Southern California Edison
WODUP A.13-10-020

DATA REQUEST SET A.13-10-020 WODUP ED-SCE-07

To: ENERGY DIVISION
Prepared by: Ayman Samaan
Title: Planner
Dated: 09/05/2014

Below is a schematic that shows the expected power flow from the generation located in Riverside County, the Path 42 Upgrade Project and the Delaney-Colorado River Project.

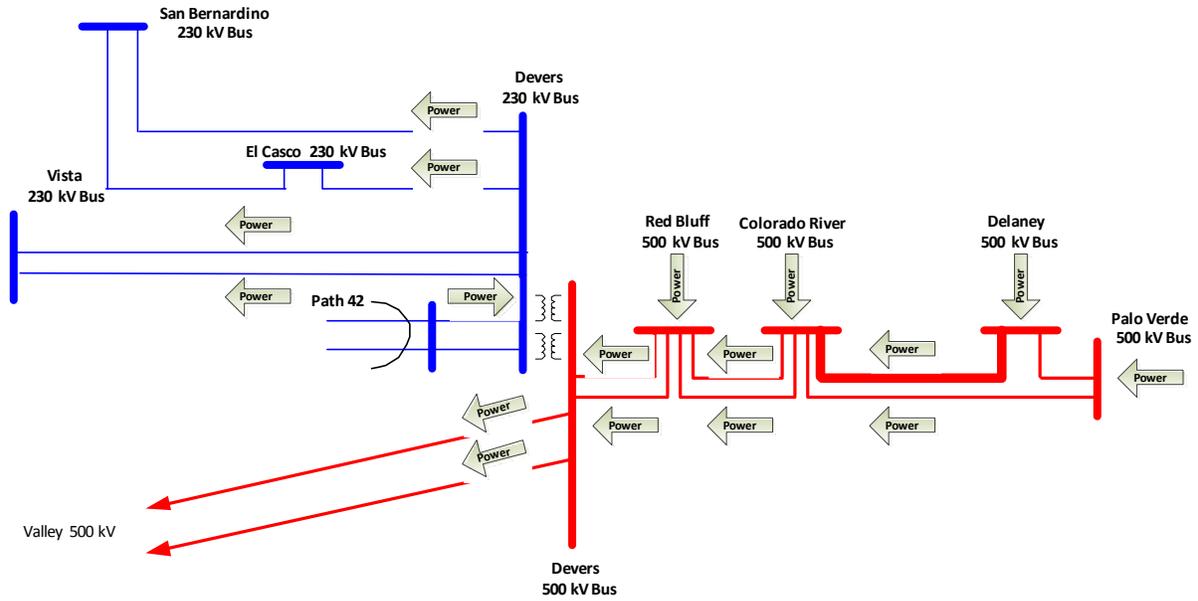
Please confirm whether an alternative that achieves at least 2,479.5 MW of transfer capacity in the WOD corridor, in lieu of the 4,800 MW anticipated under the Proposed Project (PEA p. 3-6), would provide full capacity deliverability status for the generation projects identified in PEA Table 1.1.

An alternative that achieves at least 2,479.5 MW of transfer capacity would be sufficient to provide full capacity deliverability status to only the generation projects identified in PEA Table 1.1. However, such a proposal would not be sufficient to accommodate additional flow associated with new generation in excess of that identified in Table 1.1 as well as increased flow from IID's Path 42 Upgrade Project and the Delaney-Colorado River Project. Limiting the scope of the Proposed Project to only accommodate the generation projects listed in Table 1.1 would not fully address the bottleneck on the existing WOD corridor. Since the PEA was filed in October 2013, the CAISO has received three additional requests for interconnection, totaling 500 MW of new renewable generation that require the WOD Upgrade Project to achieve Full Capacity Deliverability status. In addition, and as discussed in the PEA, the Proposed Project is also needed to facilitate the increased power flows that would result from the Path 42 Upgrade Project.

Currently, SCE and IID are in the process of upgrading the WECC Path 42 Rating from 600 MW to 1,500 MW (incremental of 900 MW). CAISO approved this project as a Policy Driven Project to increase deliverability of renewable generation out of IID's system to CAISO. The increased flow out of Path 42 would ultimately flow on the WOD corridor. Focusing only on providing for a WOD corridor transfer capacity of 2,479.5 MW would therefore have a negative impact on the ability to make use of the Path 42 upgrade and therefore impact deliverability out of IID.

The increased flow from Arizona would be enabled with the Delaney-Colorado River Project, which recently obtained CAISO Board approval based on sufficient economic benefits. The CAISO also identified that the Delaney-Colorado River Project would further increase the deliverability from Imperial Valley area. However, the Delaney-Colorado River study assumed that the WOD Upgrade Project would be in place and relied on its incremental capacity to

accommodate the additional flow corresponding to the Delaney-Colorado River Project. As a consequence, limiting the design of the WOD Upgrade Project to meet only the need of generation projects in Table 1.1 would have a negative impact on the CAISO-identified Delaney-Colorado River Project economic benefits and would limit the ability to increase the deliverability from the Imperial Valley area.

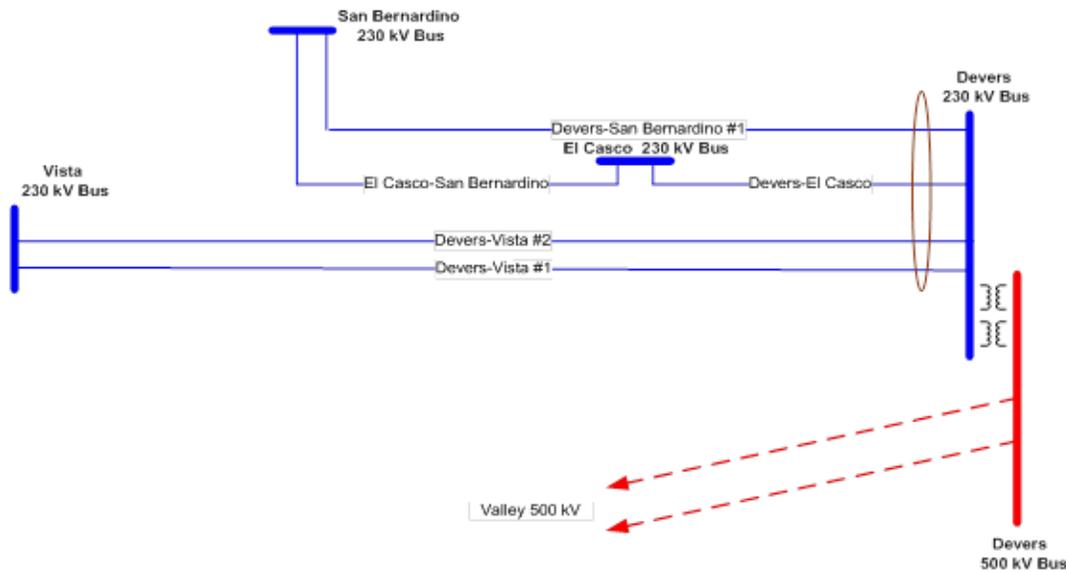
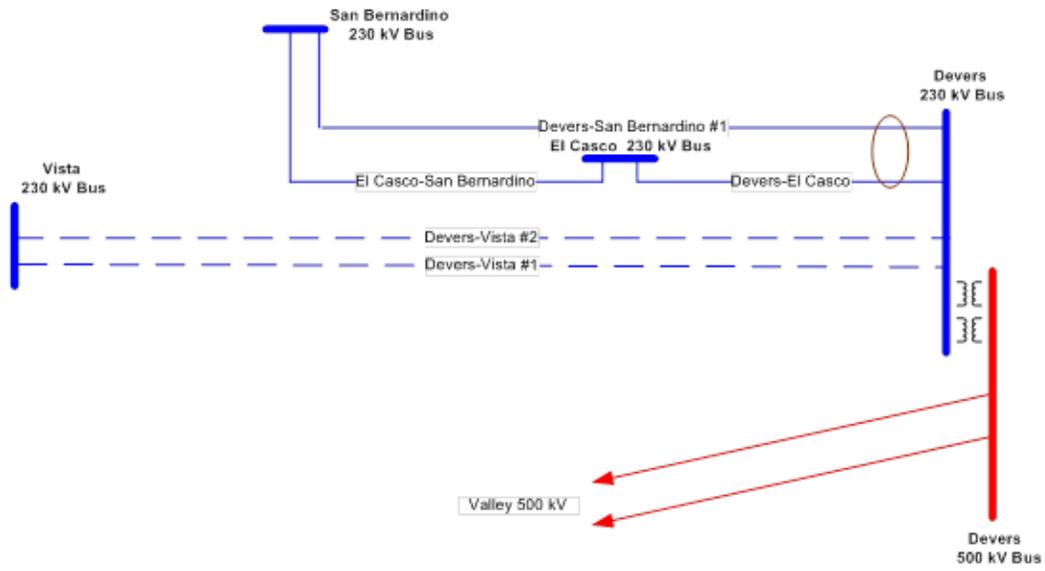
During CPUC completeness review of the PEA, SCE stated (in the 12/6/2013 Response to Question 01) that the system transfer capability increase is determined by the maximum amount of MW that can be accommodated on the facilities taking into account the NERC Transmission Planning standards. Please specifically describe the methodology used by SCE to calculate the capacity (in MW) and ampacity (Amps) for the existing and proposed transmission lines affected by the Proposed Project, including whether the controlling condition is a short term (emergency rating) or normal operation.

SCE reliability studies identified that the critical contingency under TPL-003 was the loss of Devers-Valley No. 1 and 2 500 kV transmission lines. The WOD corridor maximum transfer capacity was calculated under this contingency. The existing WOD transmission lines have no emergency capability due to limited ground clearance. The maximum flow that can be accommodated on the WOD corridor following the loss of the Devers-Valley No. 1 and 2 500 kV transmission lines contingency is 1,600 MW (which is the combined total normal rating for the four existing WOD transmission lines).

After the completion of the Proposed Project, the upgraded WOD transmission lines would have higher normal ratings and emergency ratings that can be utilized under TPL-003 contingencies. As a result, the loss of Devers-Valley No. 1 and 2 transmission lines is no longer the most critical contingency because the combined emergency ratings of the four WOD upgraded transmission lines would be higher than the combined emergency rating of two of the upgraded WOD lines under the loss of the other two upgraded 220 kV line and with the utilization of Remedial Action Scheme (RAS) that would be programmed to trip up to 1,400 MW of generation (per ISO SPS3 standards), as appropriate.

SCE reliability studies determined the maximum transfer capacity (continuous flow) to be approximately 4,800 MW under the most significant contingency loss of two of the upgraded WOD 220kV transmission lines. For example, under the loss of Devers-Vista No. 1 and 2 220 kV transmission lines (an N-2 contingency), the maximum allowable flow on the remaining two upgraded transmission lines would be 3,474 MW, which is the combined emergency rating of both lines (each remaining line has an emergency rating of 1,737 MW). With the implementation of the RAS to trip up to 1,400 MW of generation under this N-2 condition, the resultant maximum flow that could be accommodated would be 1,400 MW plus 3,474 MW, which is 4,874 MW or approximately 4,800 MW.
